ADDENDUM No. 2

DATE ISSUED: April 3, 2019

RE: RECONSTRUCTION OF VARIOUS ROADS

BID # RVR-027-040519

SHEET: SD-1
1 INCH

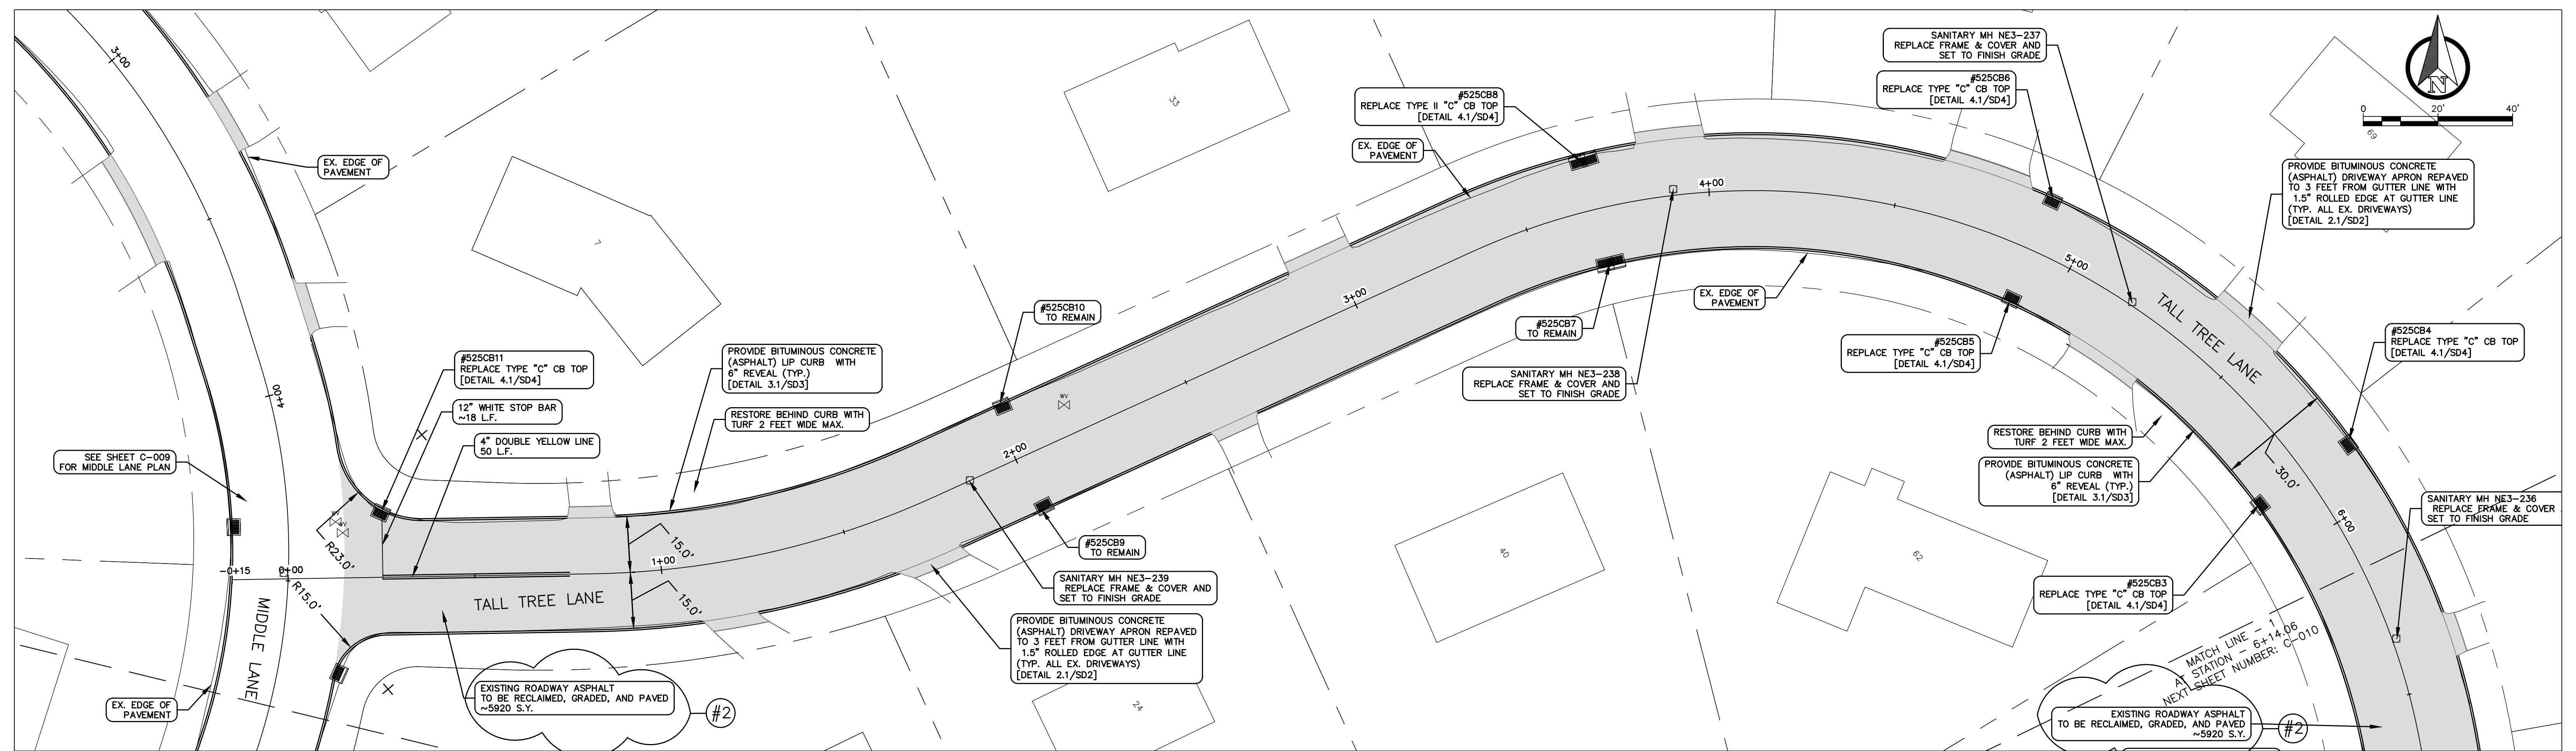
- 1. Replace Sheet SD-1 Standard Details with REVISED Sheet SD-1 noted as “REVISION ADDENDUM #2” April 2, 2019.**
- 2. Replace Sheet C-010 and Sheet C-011 with REVISED Sheet C-010 and C-011 noted as “REVISION ADDENDUM #2” April 2, 2019.**
